St. Peters Anglican College, Community Hub, Sports & Recreation Centre Project

Southern Regional Planning Panel
Request for Information

Report prepared by Colliers International Project Leaders
23 November 2023

Application No. DA0078/23

Figure 01: APZ for P10 Sports and Recreation Centre

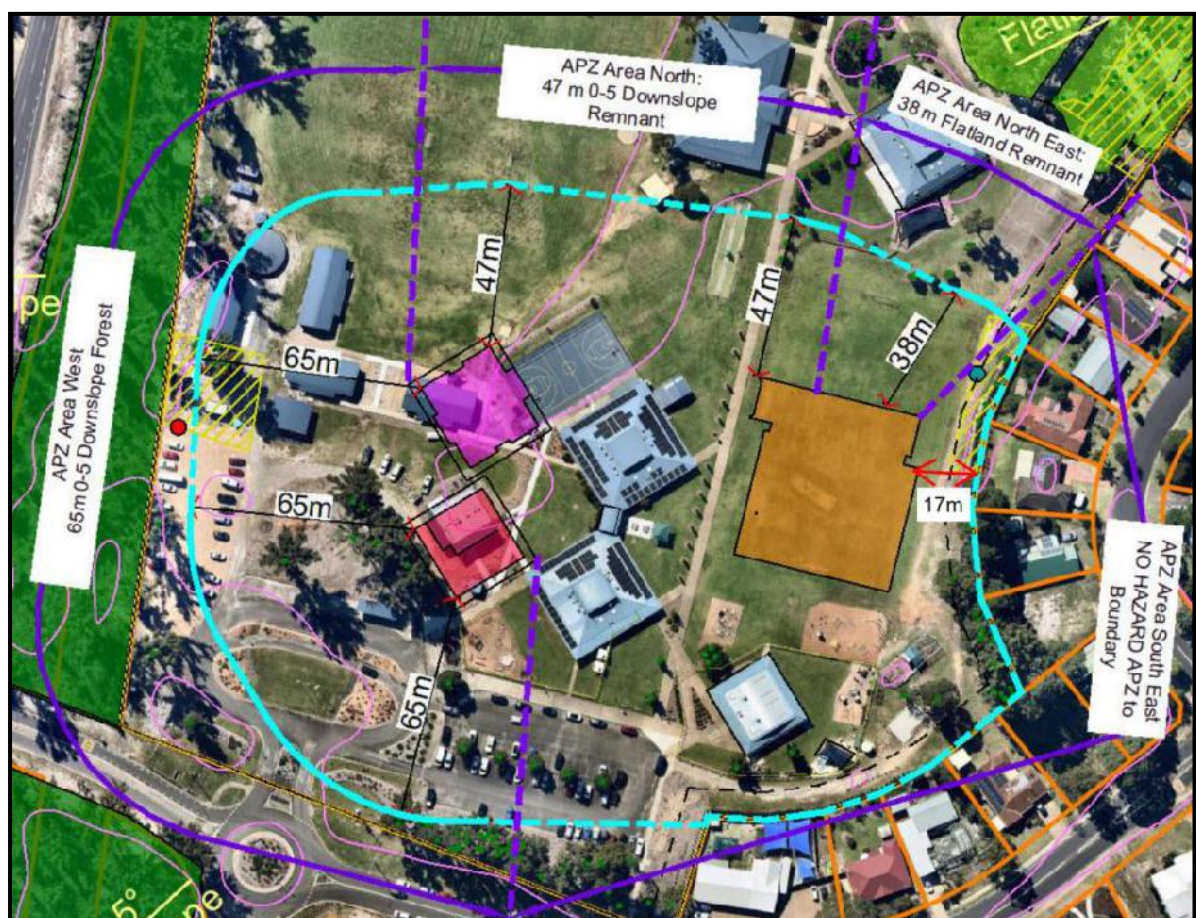
Revised NSW Rural Fire Service, 'General Terms of Approval' confirming APZ requirements for building P10 are wholly located within the site (in particular, clarification that the requirements for the 38m APZ to the east of the building P10 should be amended to require the APZ to the eastern boundary of the site).

An amended 'Bushfire Assessment Letter' has been provided at **Appendix A** to clarify the APZ surrounding the Sports and Recreation Centre (P10) - The letter clarifies the implementation of the APZ to the east of the Sports and Recreation Centre (P10) can be less than 38m because the assessment of the classified vegetation to the east is managed land, and this is not classified as a hazard. Therefore, it can be only 17m as depicted below.

Figure 02: Revised Front of Campus Carpark and Bus Loop Design

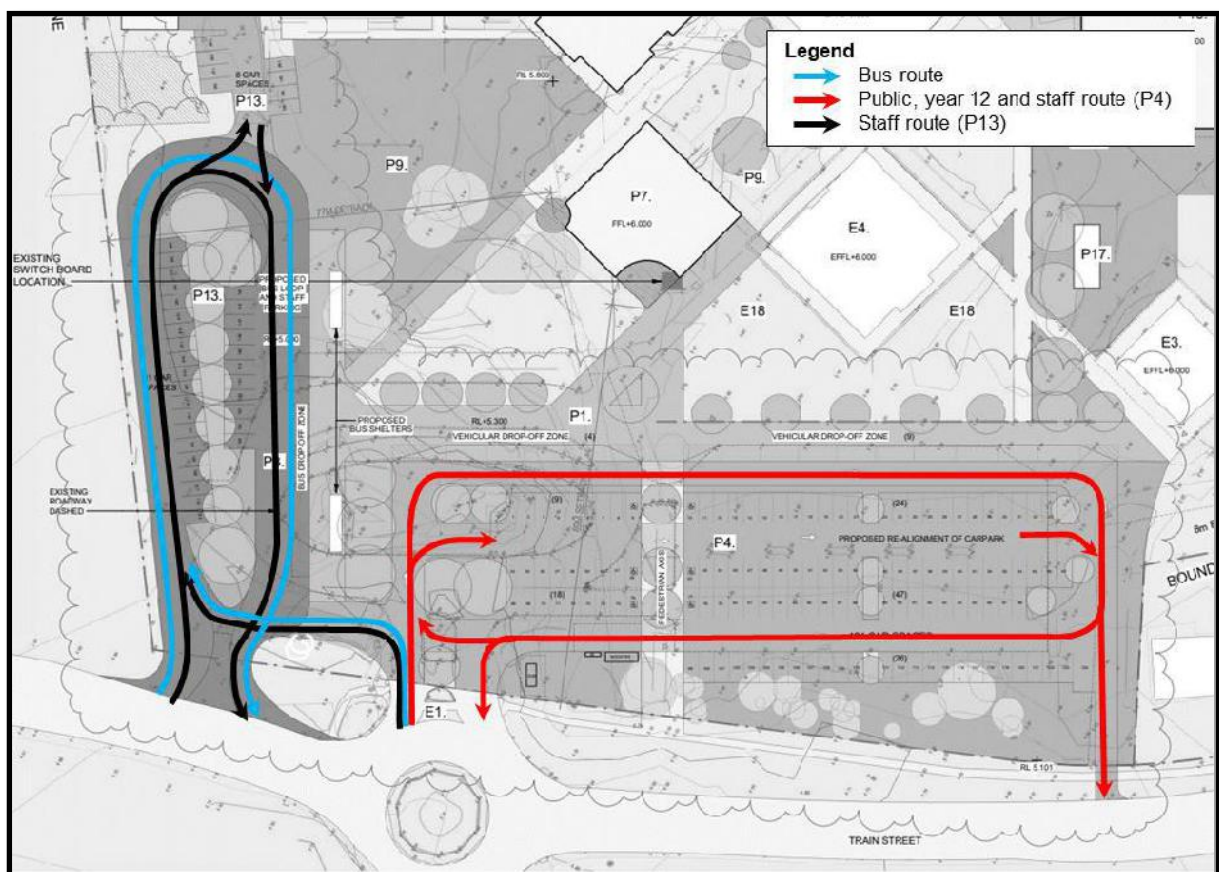
Consideration of the safety and manoeuvrability aspects for vehicles entering the staff car park (P4) from the east, using the roundabout, and clarification of traffic control arrangements for this intersection.

- The revised car park and bus loop design works hard to separate out bus and car movements as much as possible and creates a clear designation of travel path through P4 including through maintaining one-way circulation to minimise conflict of circulating vehicles.

- It is proposed to retain the existing vehicle access point in its current form with primary access via Train Street for the eastern on-site car park (P4), as well as the public drop off and pick up zone.

- An additional egress from P4 (left turn out) at the eastern edge of the car park has been provided to reduce the quantum of vehicles using the Train Street roundabout. The proposed location will result in no loss of on-street parking.

- Swept path analysis contained in the traffic report indicates the site access and car park layout has been designed to accommodate relevant design vehicles, including B99th percentile vehicles (cars, vans utes), minivan and fire appliance.

Figure 05: Acoustic Consultant mark-up showing re-orientation of mechanical plant to P10

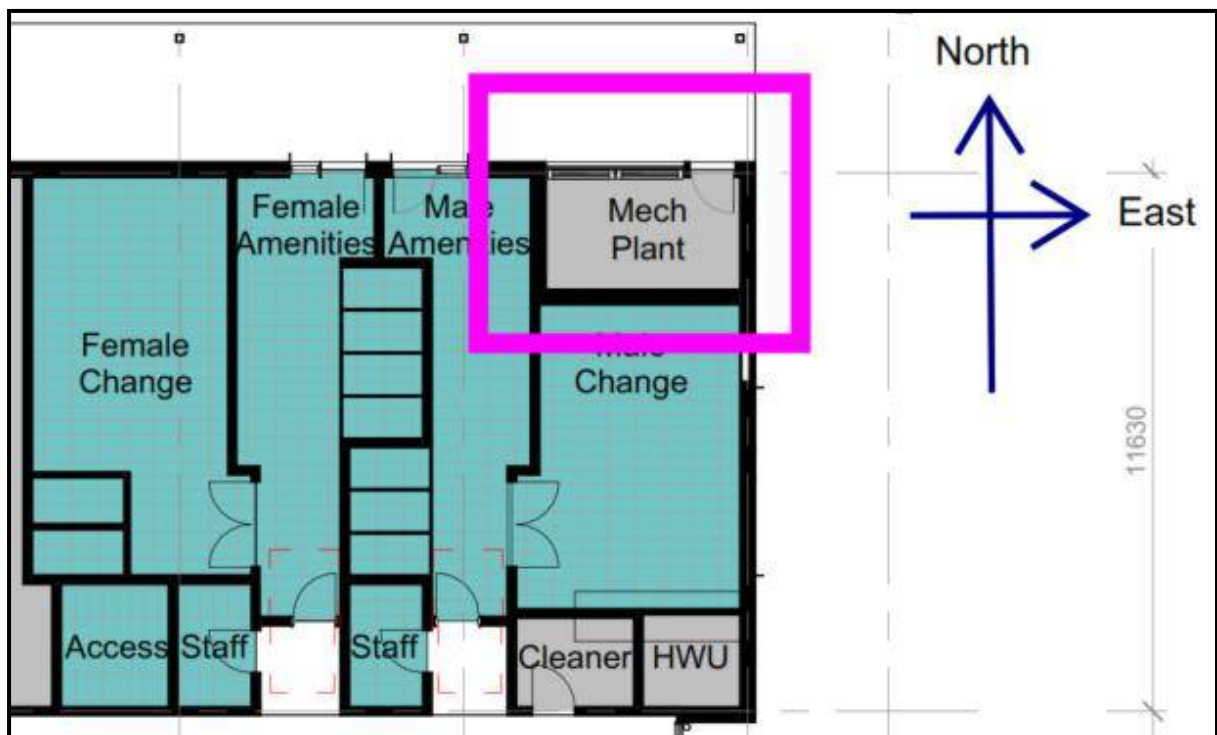
Details of the location of mechanical plant for P10 and justification for the proposed acoustic wall.

- Options and alternative mitigation measures available to negate the need for the acoustic wall; and***
- Any amendments required to the acoustic report and other relevant plans in response to any changes or updated provisions relating to the need for the acoustic wall and ongoing monitoring of noise from mechanical plant.***

The applicant has worked with the design team to re-orientate the mechanical plant room on the Sports and Recreation Centre (P10). The mechanical plantroom now opens up to the North (previously towards the

East) and based on acoustic engineering advice, this will significantly reduce noise to the east of the development.

Due to these changes and noise reduction measures, the need for the acoustic fence has also been mitigated, and therefore, can be removed improving the visual amenity and outlook from the houses.

Figure 06: Danpalon Sample Comparison between Gloss and Matt finish

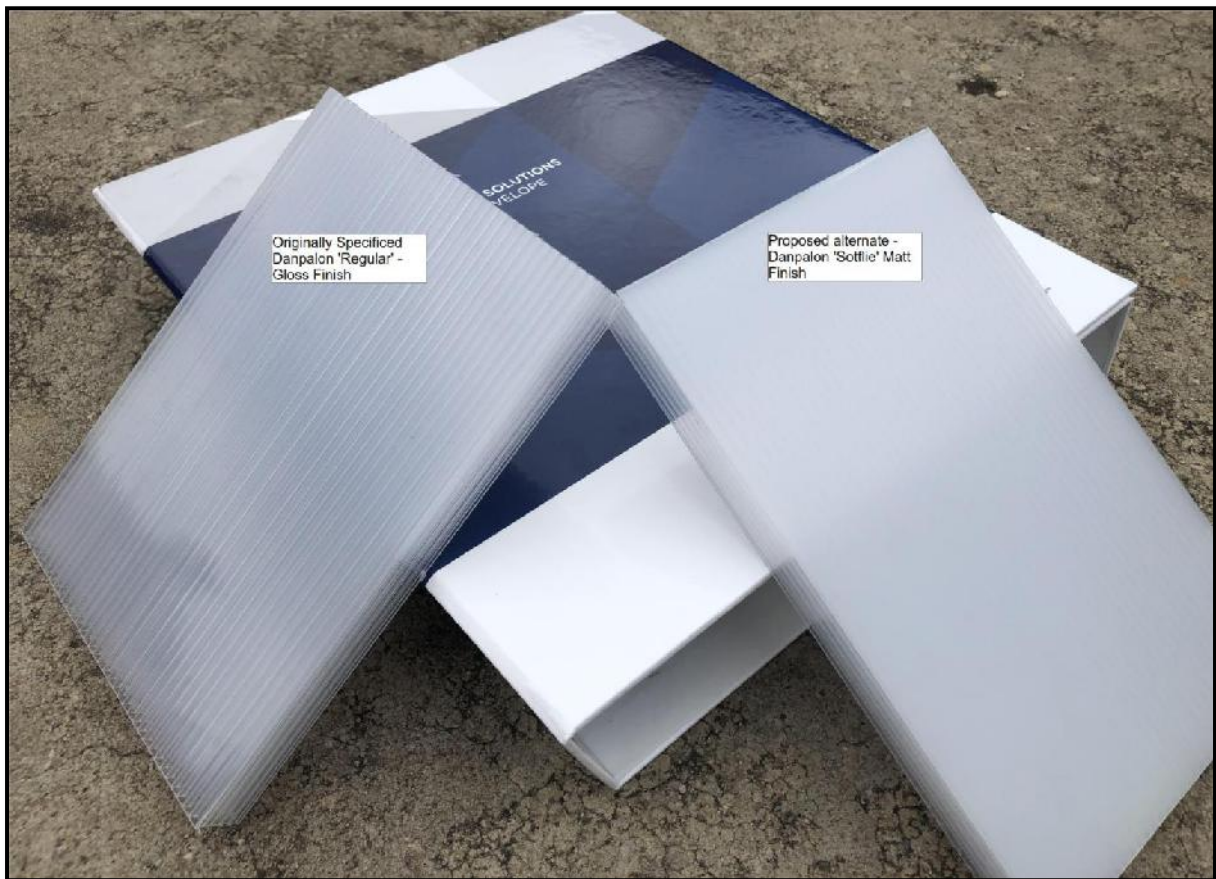
Consideration of the potential glint and glare impacts from proposed building P10 on residential receptors particularly to the east.

The luminance of the specified 'Regular' Danpalon façade product exposed to sun remains consistent with comfortable human activity visually. However, in the interest of addressing the glare sensitivity concerns of the eastern neighbours, the applicant will propose a lower glare alternative called 'Softlite' within the Danpalon range. The 'Softlite' product is a 'matt' alternative to the standard Danpalon version further reducing glare from the façade. All other properties of the Danpalon facade remain the same. See **Appendix D** with a copy of the glare data comparison between 'Regular' and 'Softlite' Danpalon.

FIGURE 1 140M VEGETATION FROM PROPOSED DEVELOPMENT

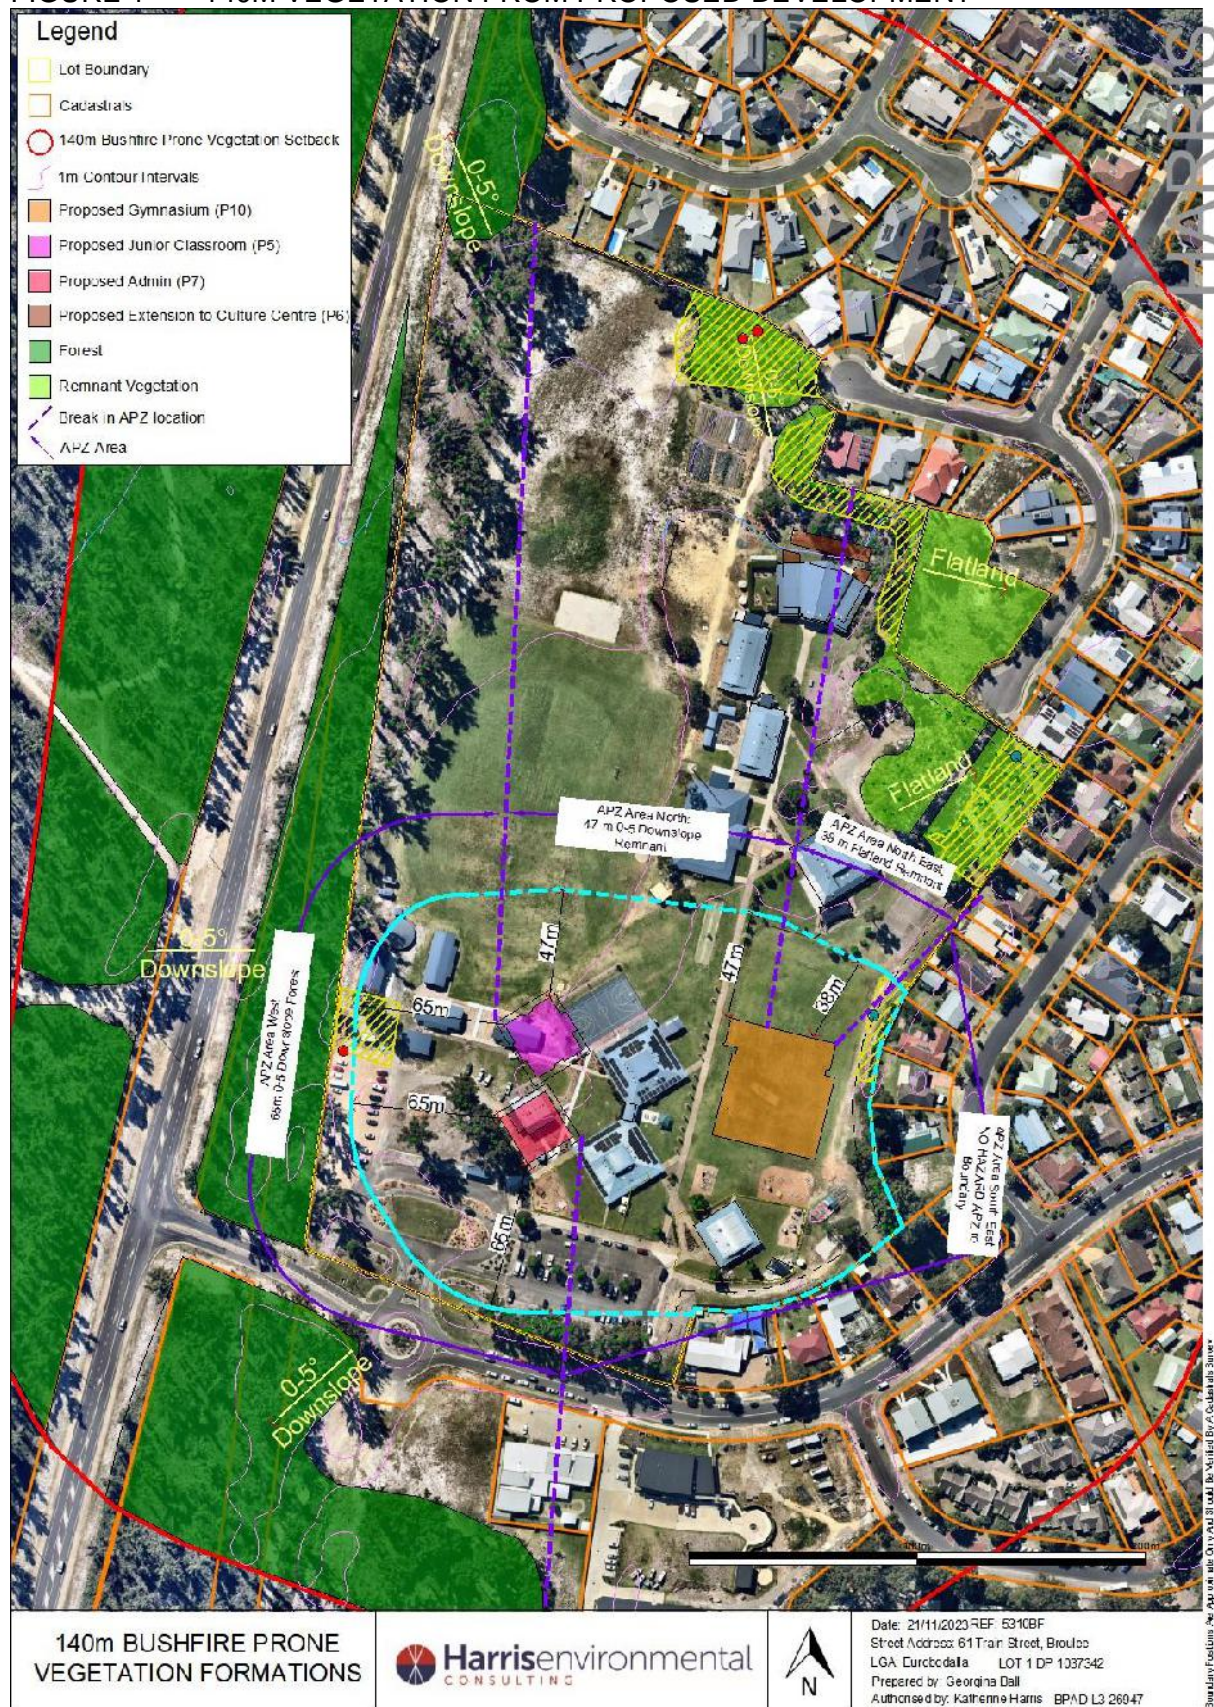
1. Revised NSW Rural Fire Service, 'General Terms of Approval' confirming APZ requirements for building P10 are wholly located within the site (in particular, clarification that the requirements for the 38m APZ to the east of building P10 should be amended to require the APZ to the eastern boundary of the site).
7. Consideration of opportunities for additional landscaping to provide a more sympathetic outlook for residents located to the east of building P10 taking into consideration the need to establish the APZ.

All Asset Protection Zones (APZ) comply with the NSW GTAs in that they are provided for the distance *in the direction of the hazard only*.

As shown in Table 1, the assessment of the classified vegetation formations detailed in the Bushfire Hazard Assessment includes managed land to the east of the proposed development. The identified bushfire hazard is located in the north, northeast, south and west, as detailed in Table 1. The bushfire hazard on the north and east is within the subject site; therefore, the APZs are also provided within the subject site in the direction of the bushfire hazard.

Table 2 from the Bushfire Hazard Assessment summarises Table 1 into the remaining vegetated directions and the associated APZs. An APZ is not required for the direction for which the land is managed, only for that in the direction of the hazard. A visual depiction of this APZ is illustrated in Figures 1 and 2, where the APZ directions are segmented in purple. The APZs are consistent with the GTAs provided by the NSW RFS. It should be noted this APZ is not located in land mapped Biodiverse.

Figure 2.2 – Site layout with indicative line marking

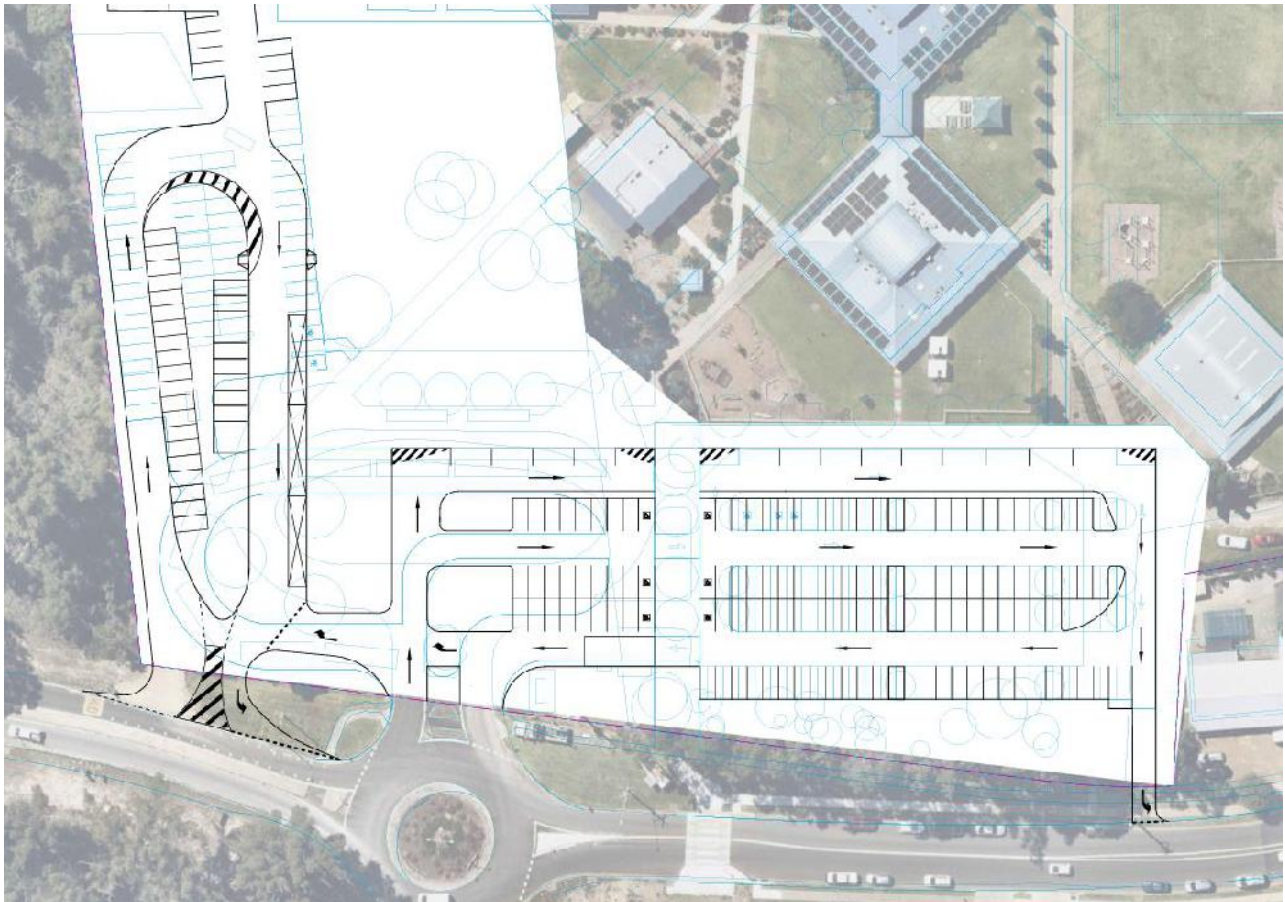
3. Consideration of the safety and manoeuvrability aspects for vehicles entering the staff car park (P4) from the east, using the roundabout, and clarification of traffic control arrangements for this intersection.

As shown, the line marking is proposed to reinforce the one-way circulation of P4, as well as reinforce main carriageway through use of give way line marking, ensuring there's limited conflict points.
